## **Arlington Zoning Board of Appeals**

### Thorndike Place - Revised Draft Decision

**DECISION ON APPLICATION FOR COMPREHENSIVE PERMIT**  
**G.L. c. 40B, §§ 20-23**

DEVELOPMENT NAME: Thorndike Place

ILLUSTRATIVE LANDSCAPE PLAN  
THORNDIKE PLACE  
DORTHY ROAD IN ARLINGTON MASSACHUSETTS

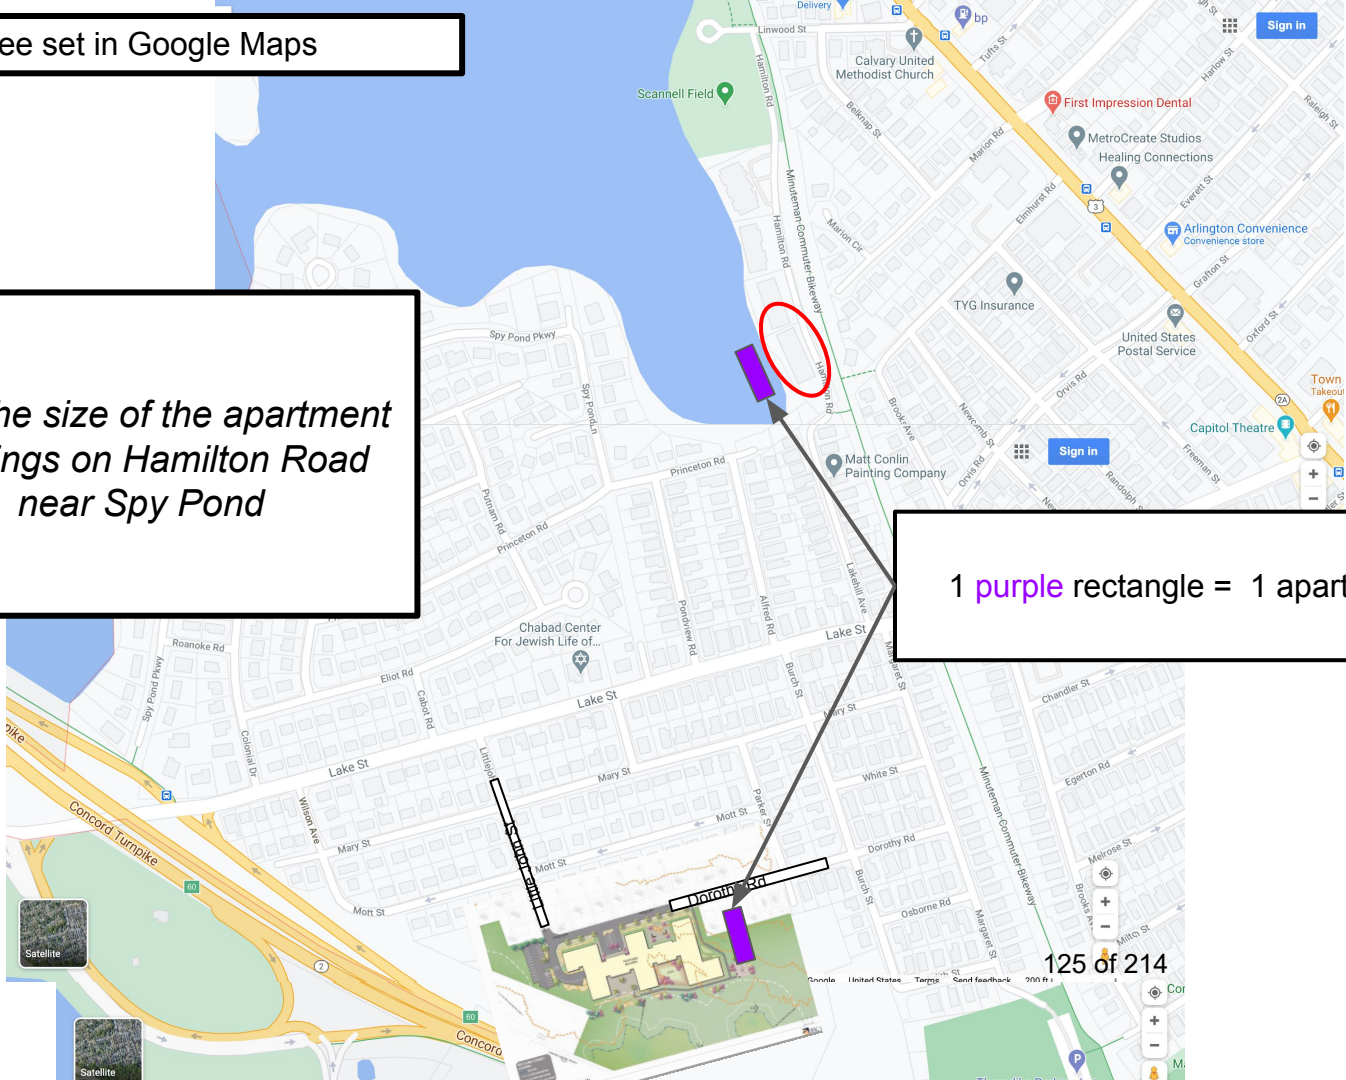
Here's what I learned...

Here is the Image from Oaktree Developers

*(As can be seen in MDM's "Figure 2," both the Rt. 2 Ramp and Burch Street and Parker Street access were prominent features of the Site Plans submitted for Site Approval to MassHousing)*

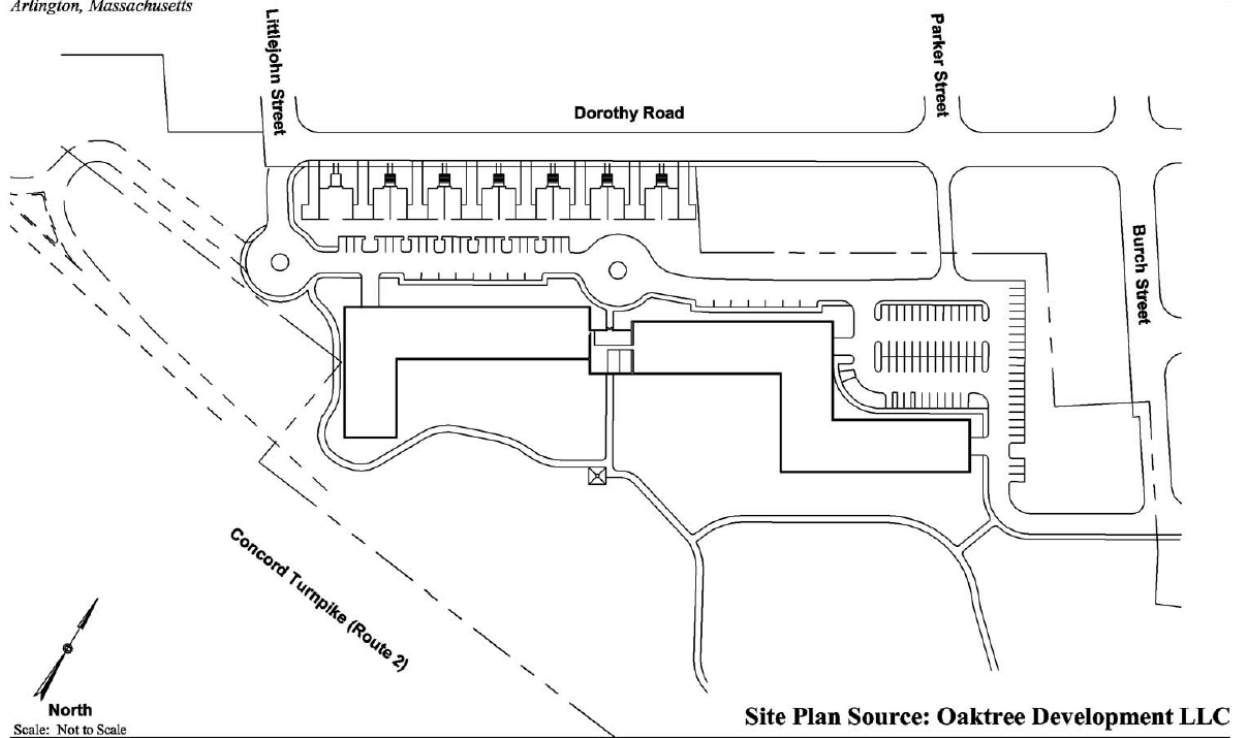
### **A. Reduced Traffic Access Points & No Access from Route 2**

See MDM Traffic Impact and Access Study at E.1 p. 2; and Figure 2. (emphasis added).

Figure TC-2  
Lake Street Intersection  
Improvement Locations

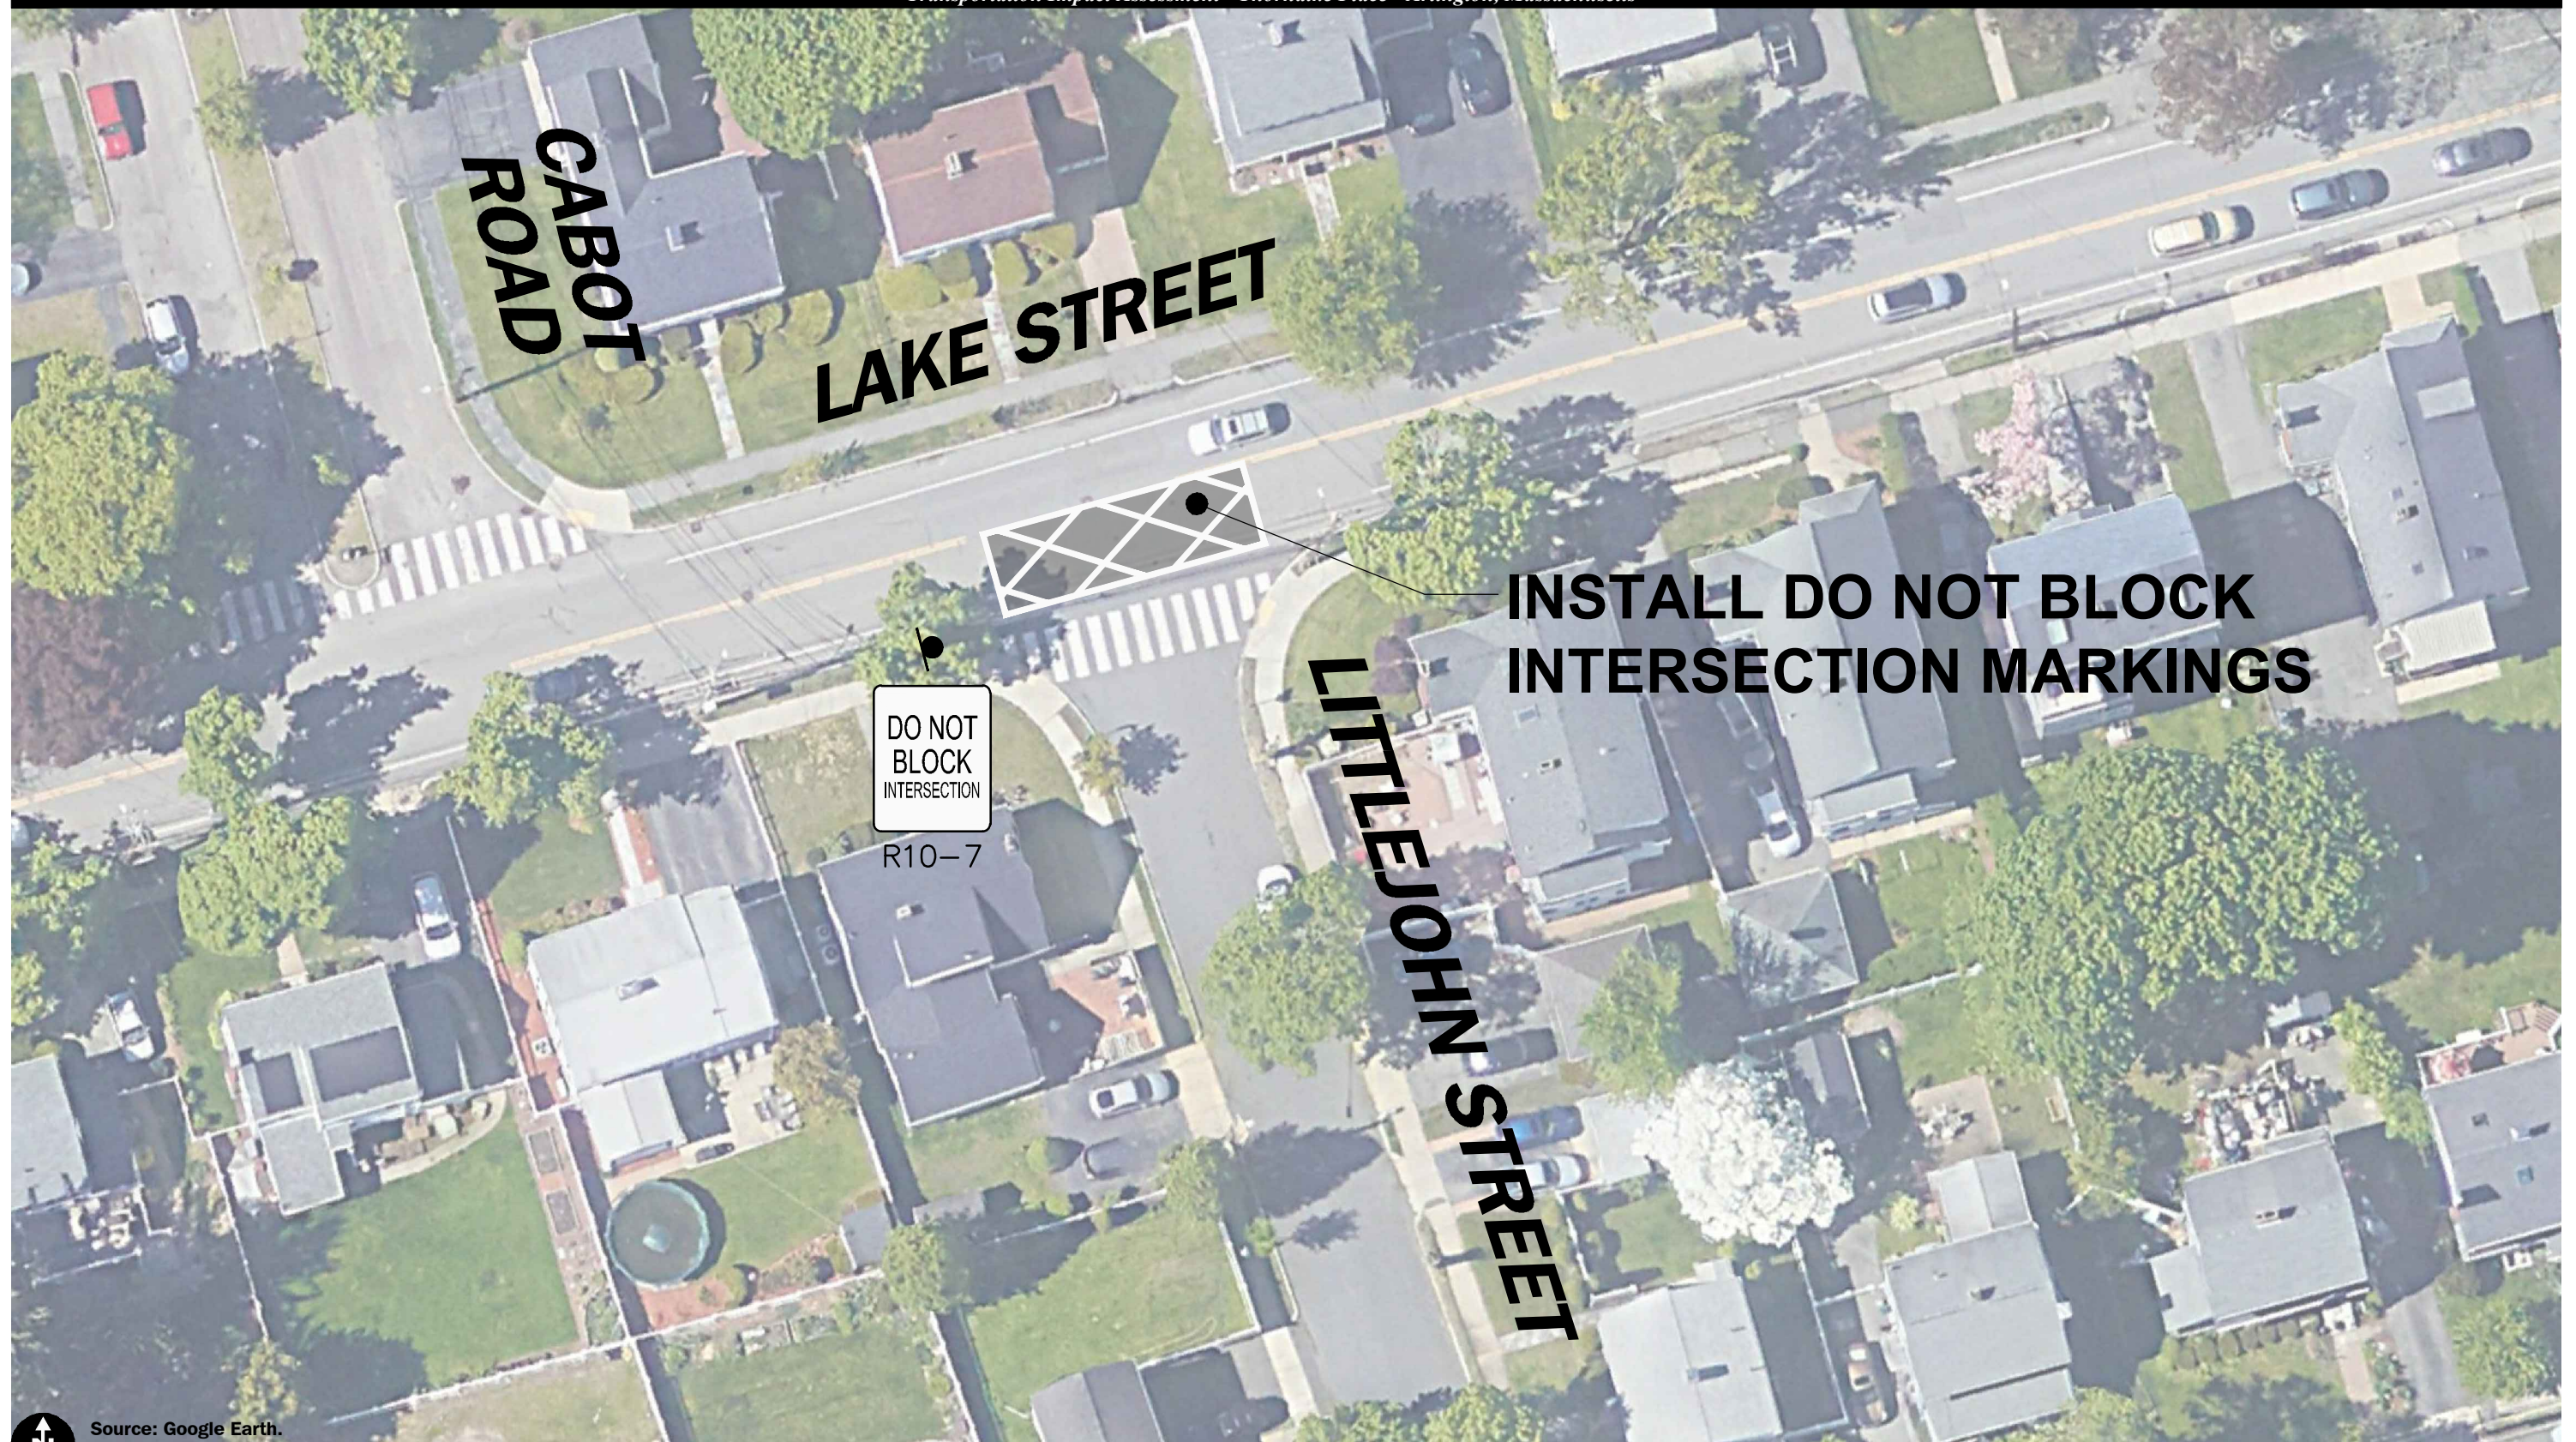
In addition to the measures identified by BETA and agreed to by the Applicant, the Applicant has committed to the installation of a 23-dock Bluebikes station in the vicinity of the surface lot; committed to discussions with Zipcar to make available up to two surface parking spaces for Zipcars; and agreed to provide 176 covered and secure bicycle parking spaces in the garage. The Applicant has also agreed to provide “Do Not Block” intersection pavement markings at the intersections of Lake Street with Littlejohn Street, Burch Street, and Margaret Street, as shown on Figure TC-1 and TC-2.

*(As can be seen in MDM's "Figure 2," both the Rt. 2 Ramp and Burch Street and Parker Street access were prominent features of the Site Plans submitted for Site Approval to MassHousing)*

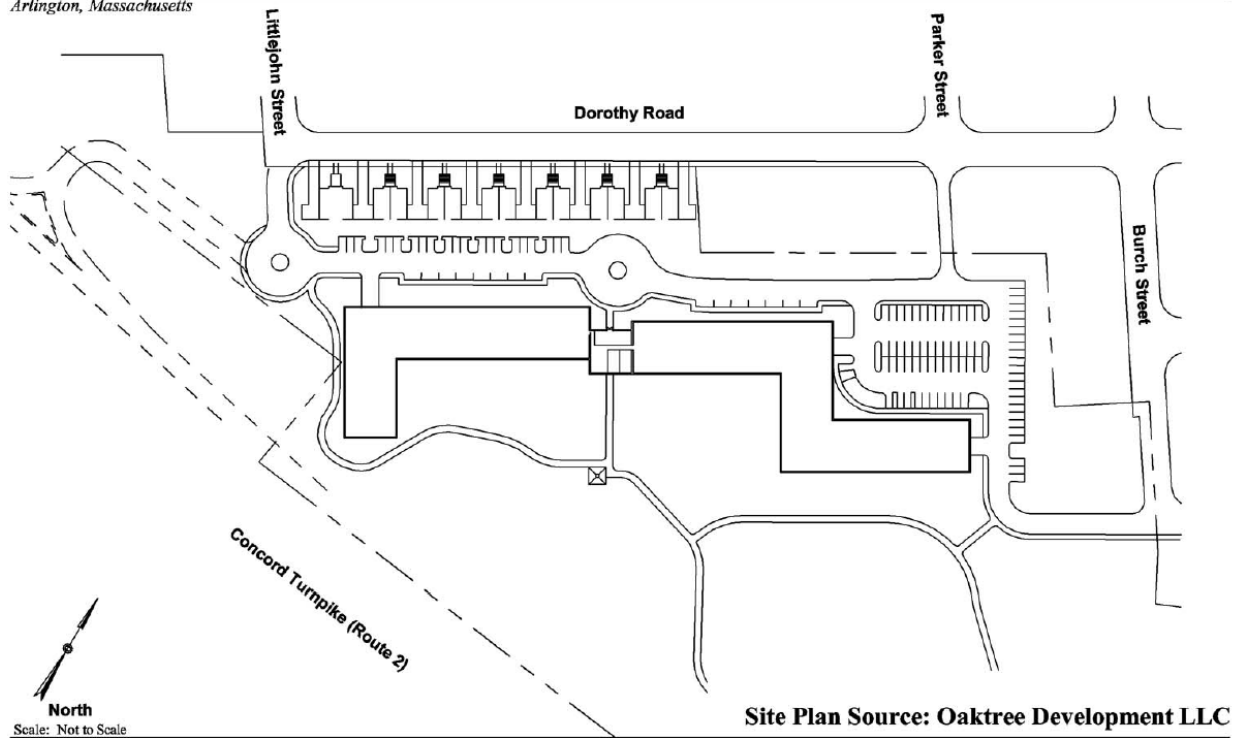
### **A. Reduced Traffic Access Points & No Access from Route 2**

One of MassHousing's principal findings with respect to the general appropriateness of the site for redevelopment was that "[t]he Site is accessible to Route 2, which borders the site." See Eligibility Letter at Attachment "1;" Findings "(b), p. 8. Indeed, both the site plans submitted by the Applicant to MassHousing, and the April 2014 Traffic Impact and Access Study by MDM Transportation Consultants highlighted access to Route 2 a feature for MassHousing given the constraints of the modest neighborhood streets otherwise necessary for ingress and egress. As MDM's report stated:
